SUBJECT: Contract No. DE-AC24-03OH20152  
Contract Deliverable 039 – PRS Documents  
**PRS 11 PUBLIC FACT SHEET AND PACKAGE**

# Response to Comments

on PRS 11: Thorium and Polonium Contaminated Waste Area  
Public Fact Sheet Draft, 2003

## **PRS 11**

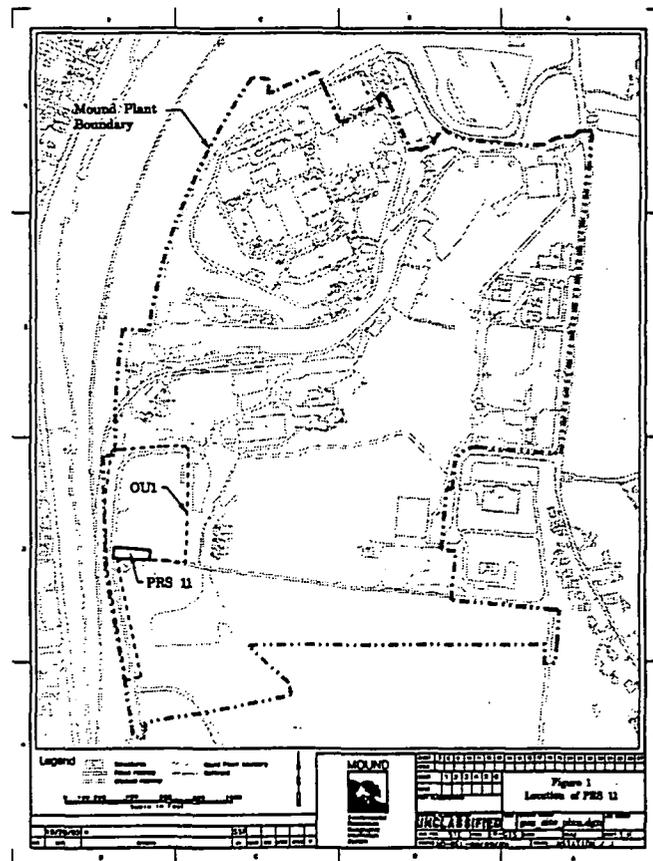
**Comment 6:** Figure 1, Right Column. This figure should be labeled as "Figure 1" (unless it already is, and it did not show on the screen and print out).

**Response 6:** On Figure itself.
